TLG Comment on Setbacks

14th December 2015

Generalised widths vary with riparian functions

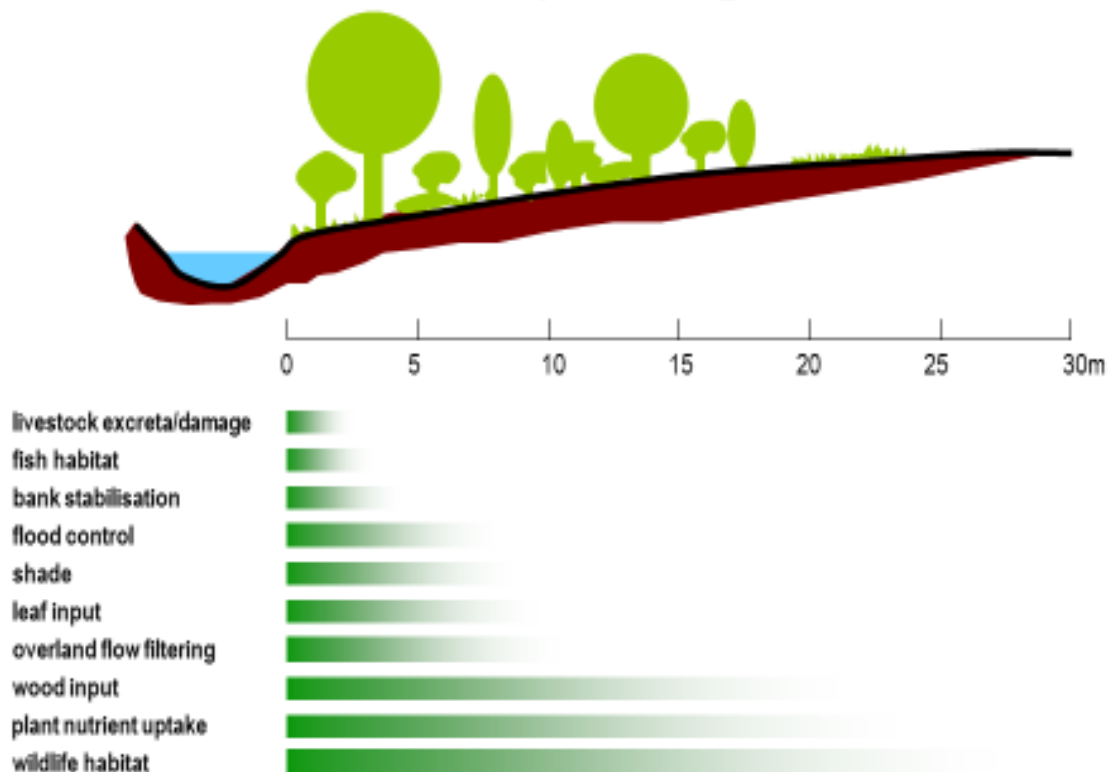
4. Although the focus of the CSG's deliberations is in dealing with the four contaminants, riparian setbacks can serve a wider range of ecosystem services including those associated with benefits to stream ecosystem health and biodiversity. Where these other benefits are important, then setback distances (and other aspects of riparian design) need to be established accordingly. A generalised view of this is presented in the diagram below and the interested reader is referred to a presentation from John Quinn available at <http://agscience.org.nz/PDF/John%20Quinn.pdf>
